Date: 2024.05.10
Project Name: KCKHA Parking Repairs, Package #2
Veritas Project #: 22.39

i. D00, PARKING LOT REPAIR PLAN (DOUGLAS HEIGHTS HIGH RISE):

ii. R00, PARKING LOT REPAIR PLAN (ROSEDALE TOWERS):

1 OVERALL PARKING LOT REPAIR PLAN - DOUGLAS HEIGHTS HIGH RISE
1" = 20'-0"

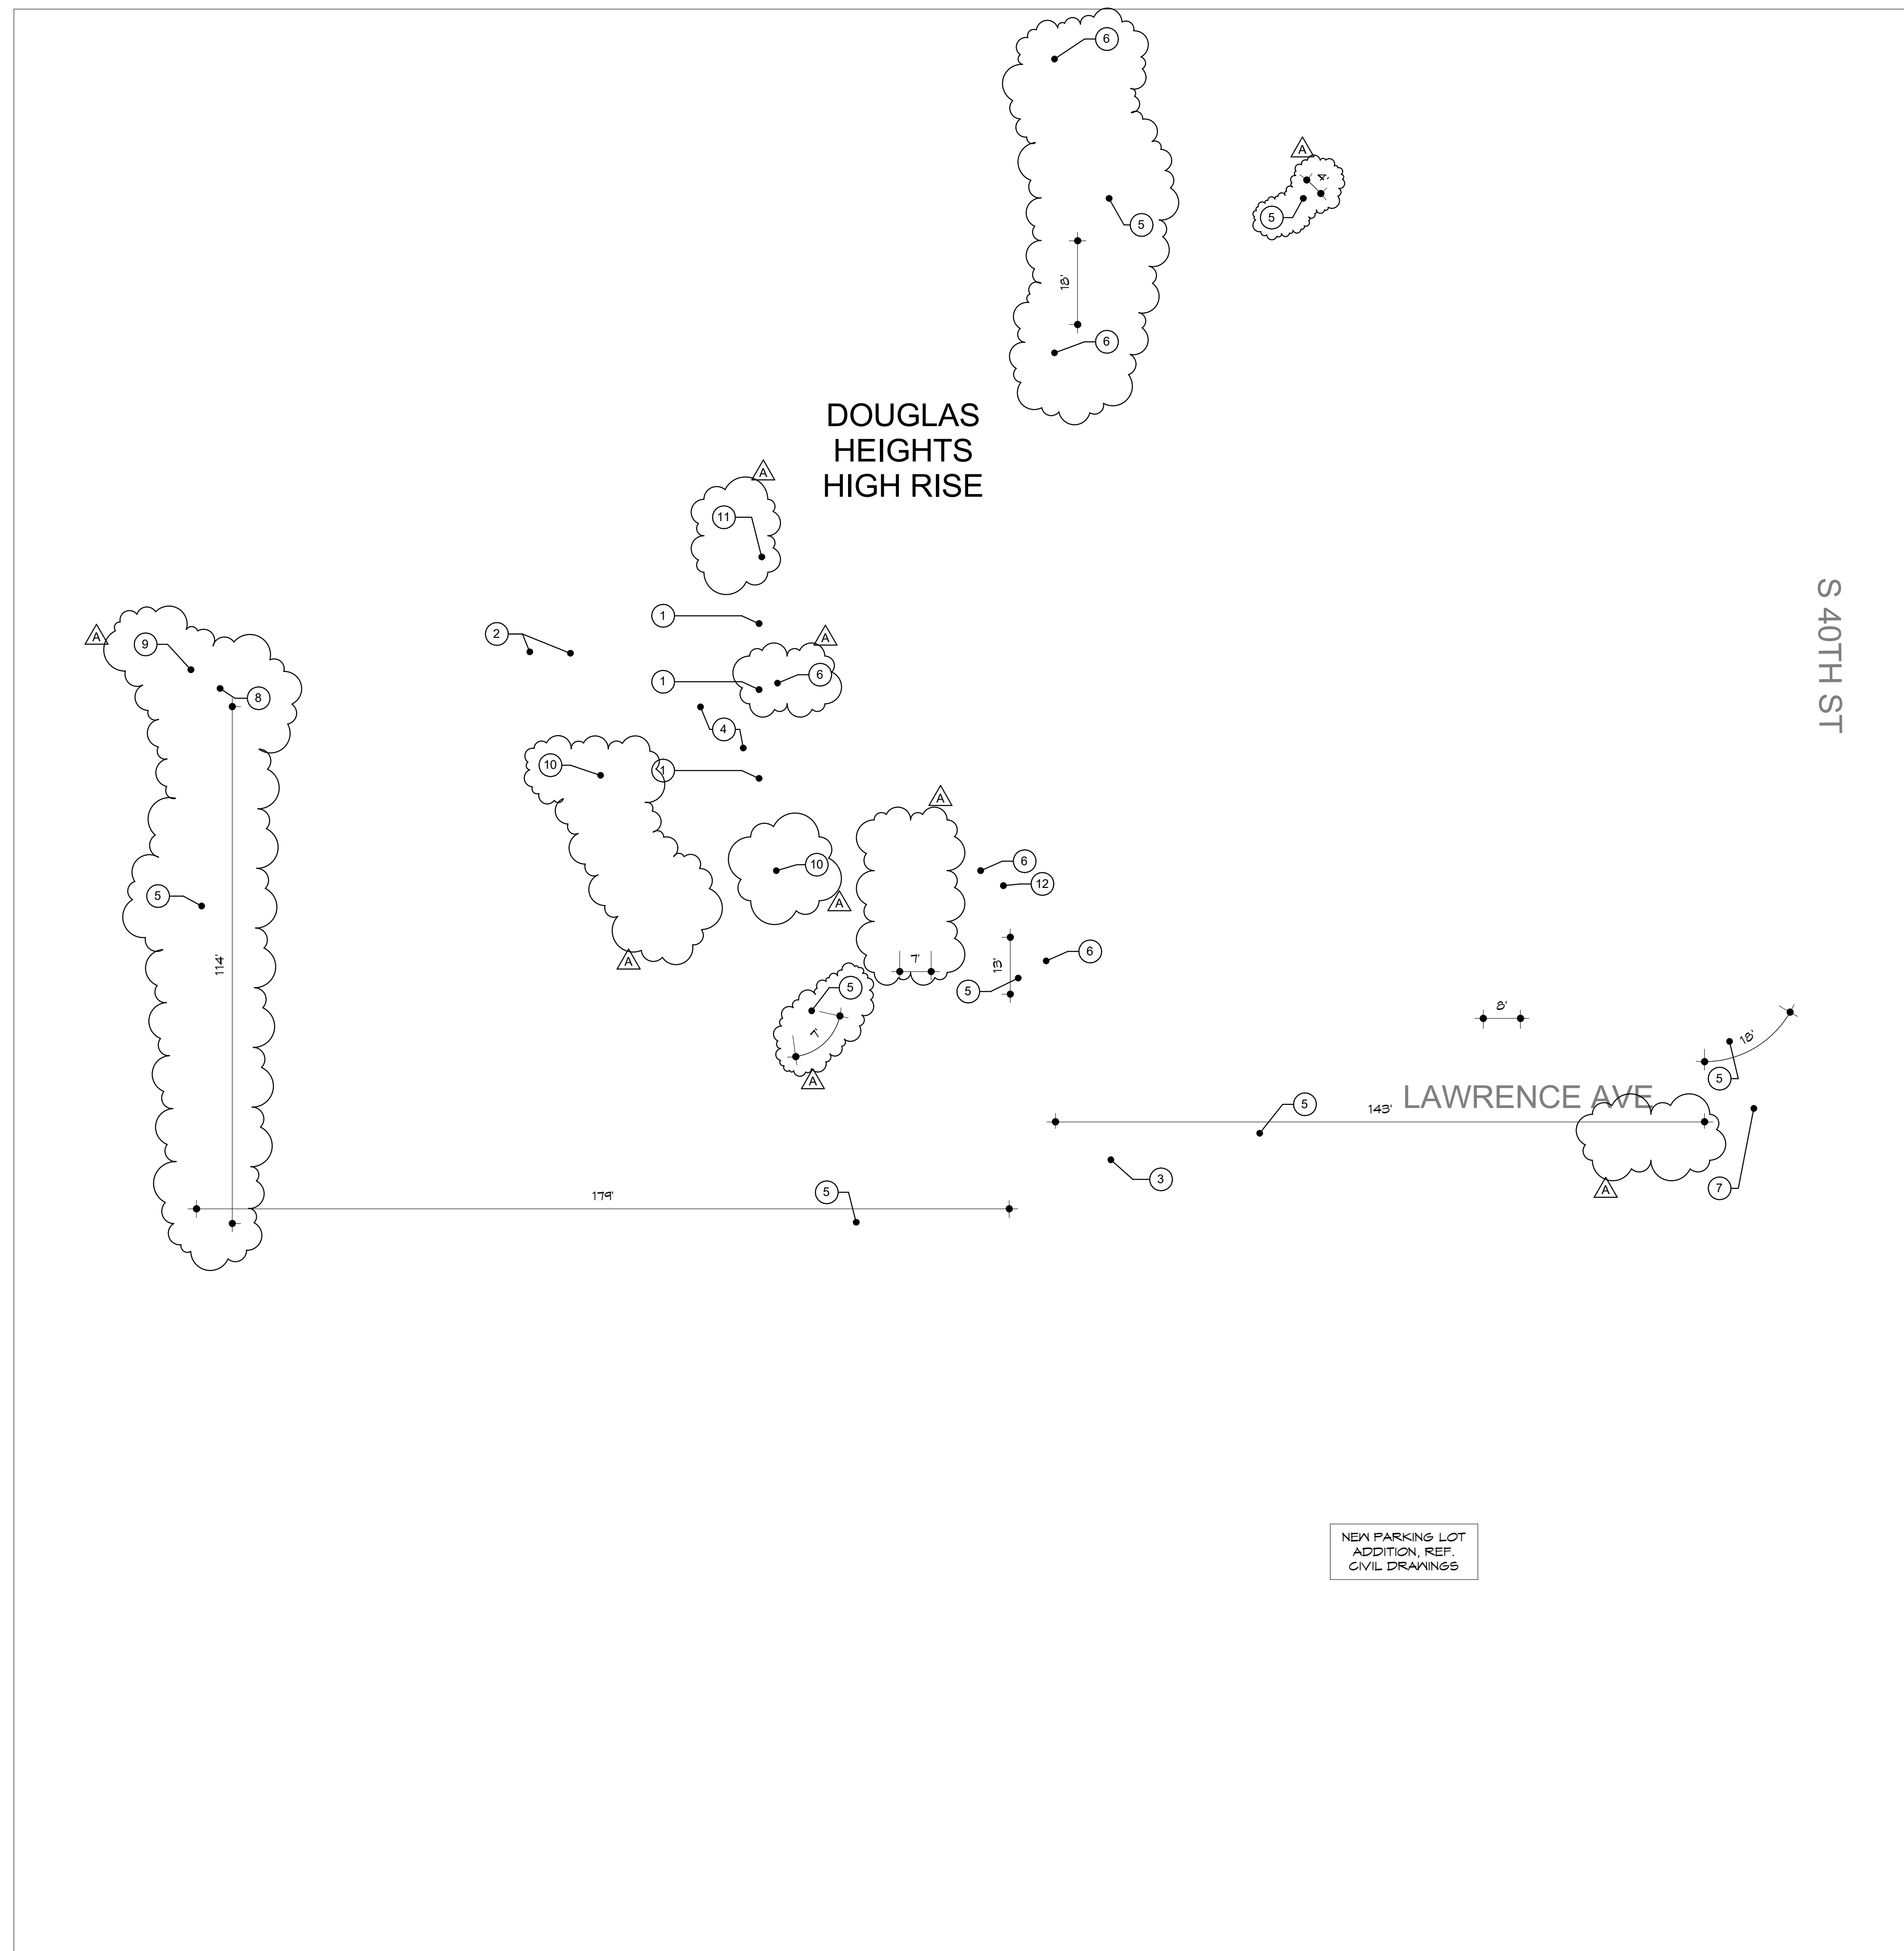
1. Added and/or expanded several locations for sidewalk and curb repair.
In turn, increased repair quantities.
2. Revised notes on dock wall.
3. Mill & Overlay on legend revised, simplified.
4. General note on 'patch repair all curbs and sidewalks' removed.

Q: General repair note (2) on sheet R00 & D00 references sheet G01 for seal specifications – there are notes on sheet G02, are these the correct notes?

Q: D00 & R00 notes for mill and overlay are unclear – is the pavement restoration to follow detail 1 or 2 on sheet G02? The note for sealcoat is also unclear, is this in addition to the mill and overlay?

Q: There is a general note on both sites, note (1) R00 & D00, to patch and repair all curbs and adjoining sidewalks. Is a polymer repair material acceptable for this? Or are these to be removed and replaced?

A: Yes. Respective note revised to reference sheet G02.

A: Detail 2. Sealcoat not designated for these projects. Please disregard the standard note commonly utilized in other projects.

A: Patch repair only curbs and sidewalks designated in drawing plans. Respective note to be removed in Addendum.

1 OVERALL PARKING LOT REPAIR PLAN - ROSEDALE

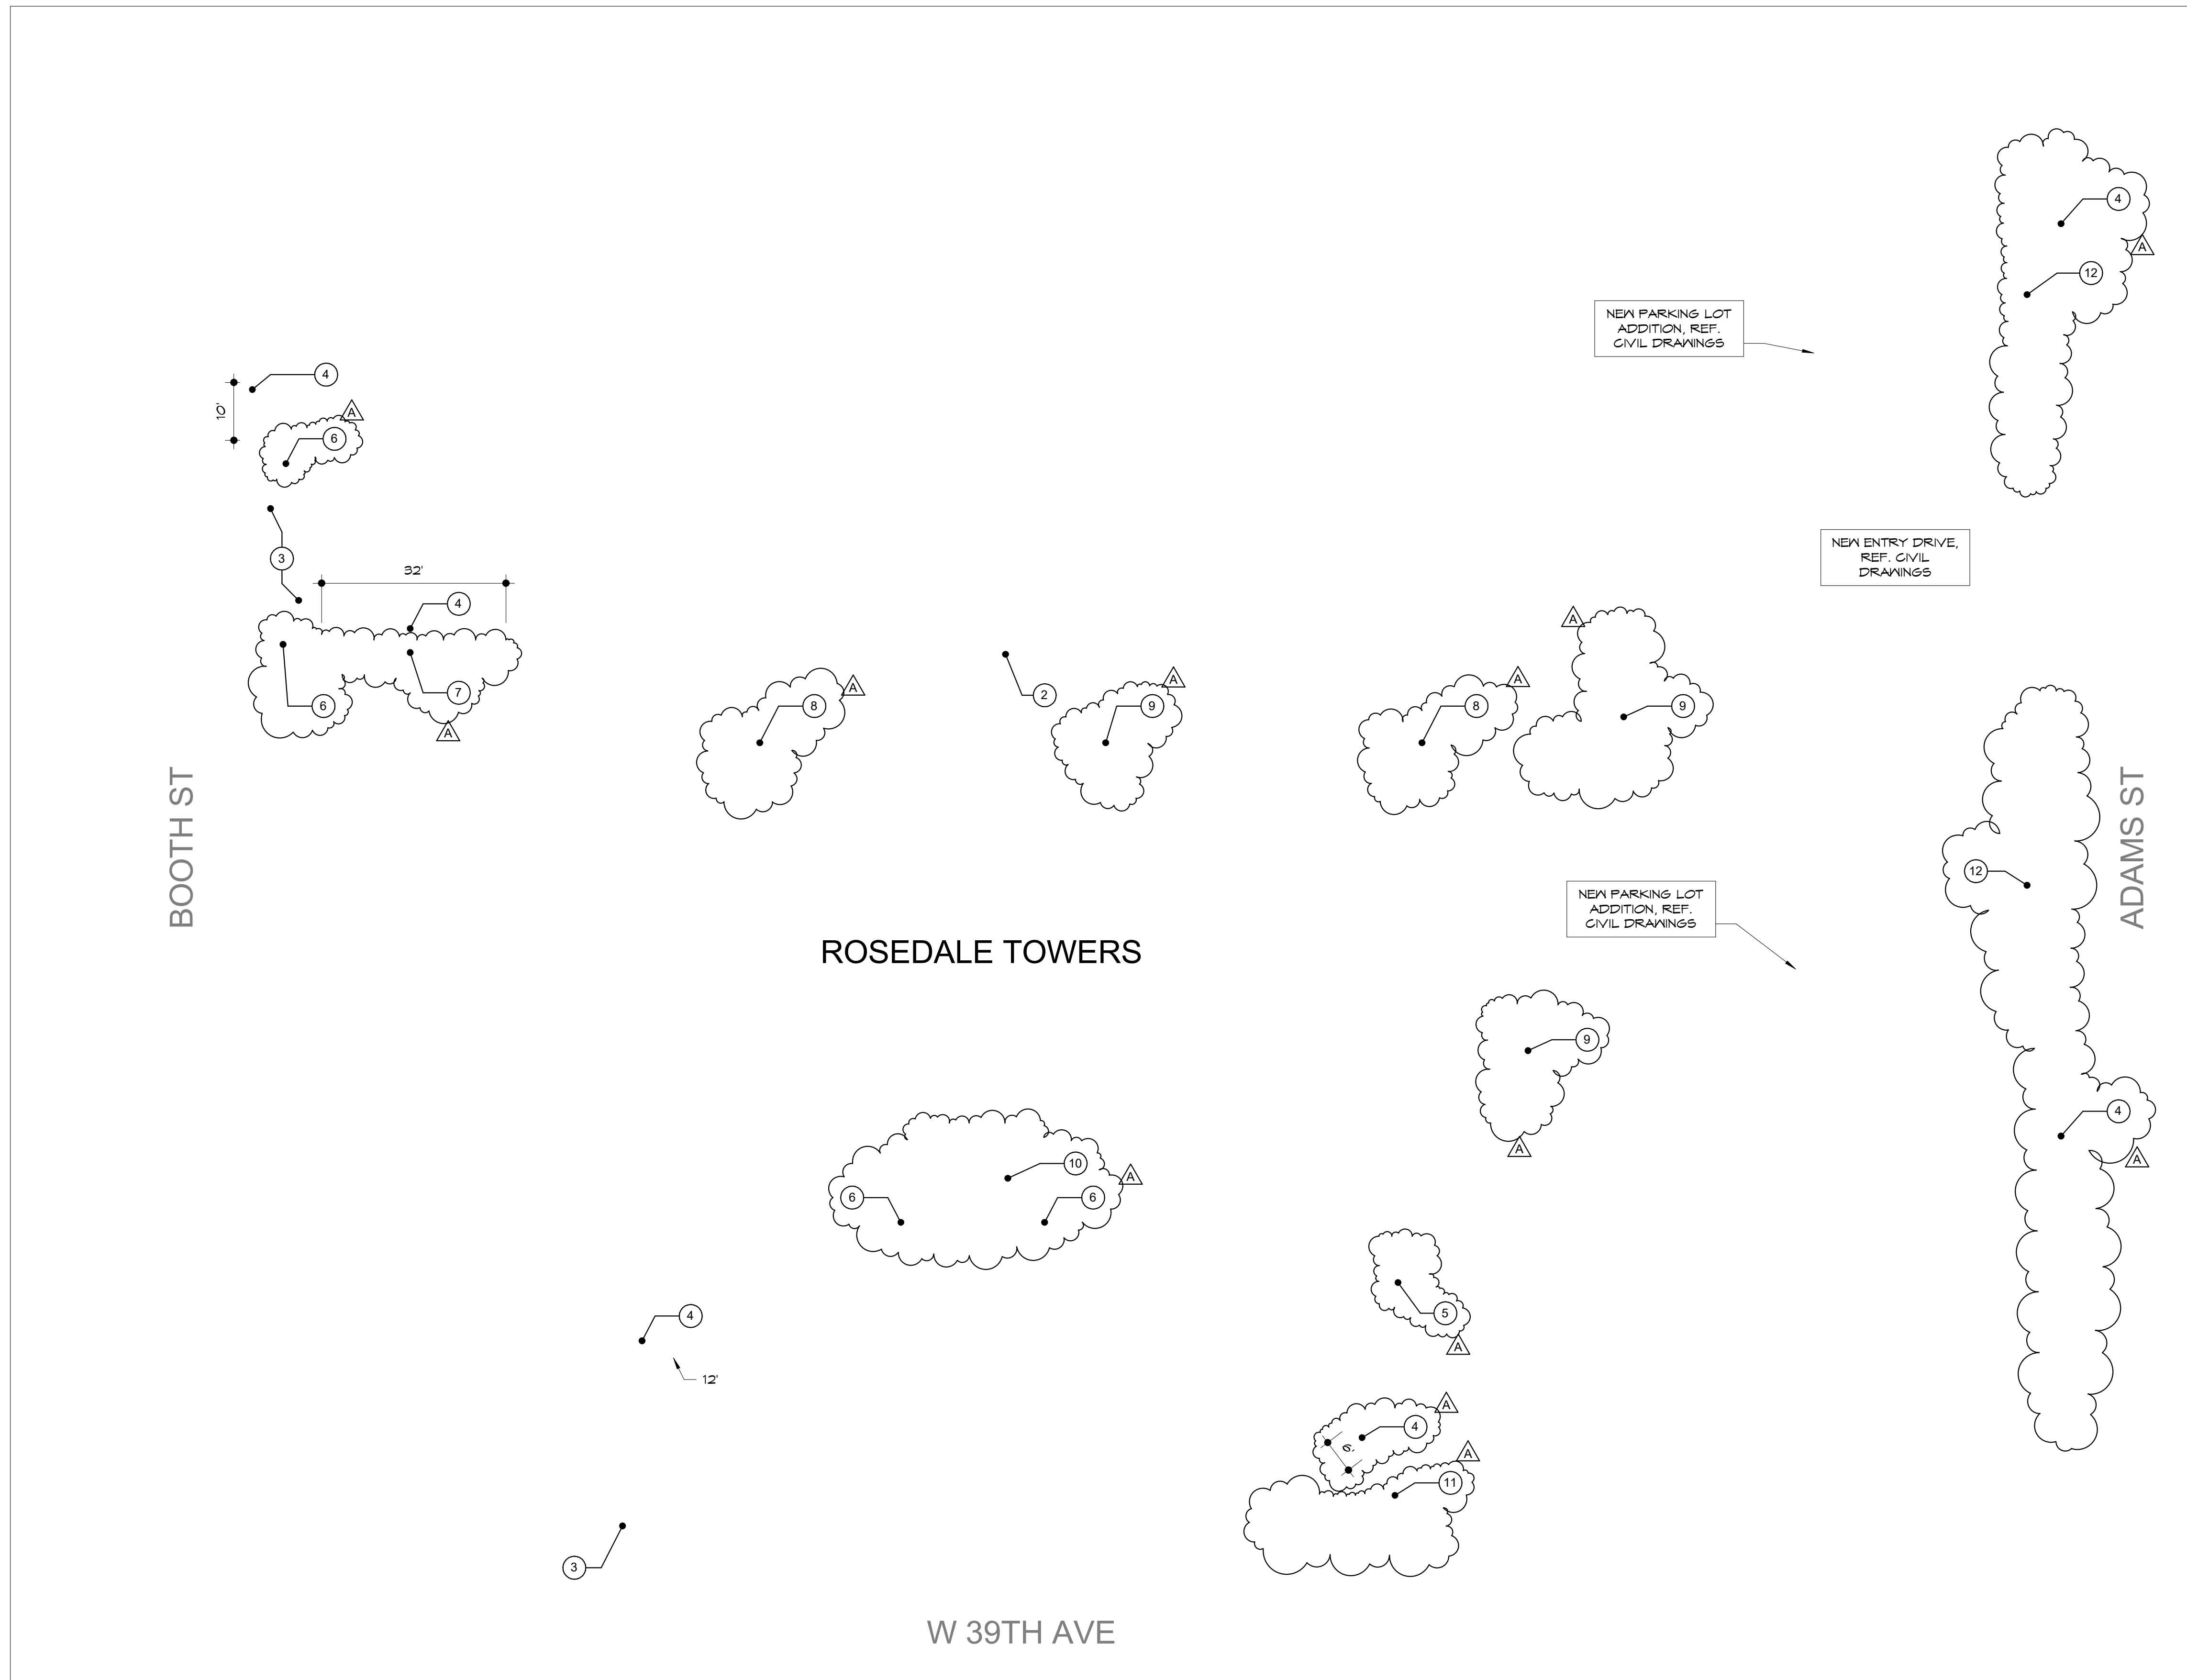
1. Added and/or expanded several locations for sidewalk and curb repair.
In turn, increased repair quantities.
2. Mill & Overlay on legend revised, simplified.
3. General note on 'patch repair all curbs and sidewalks' removed.

Q: Sheet R00 shows us milling & overlaying through the drives on W 39th Ave. Are you wanting these concrete drives milled, removed/replaced, or should we just mill/overlay up to the drive edges?

Q: Are the concrete drive approaches on W 39th at Rosedale Heights, R00, to be repaired? The mill and overlay limits include these two drives.

- West: to be replaced. Updated revision will be released in Addendum
- East: existing approach to remain. Mill and overlay to edge of existing approach.

- West: to be replaced. Updated revision will be released in Addendum.
- East: existing approach to remain. Mill and overlay to edge of existing approach.
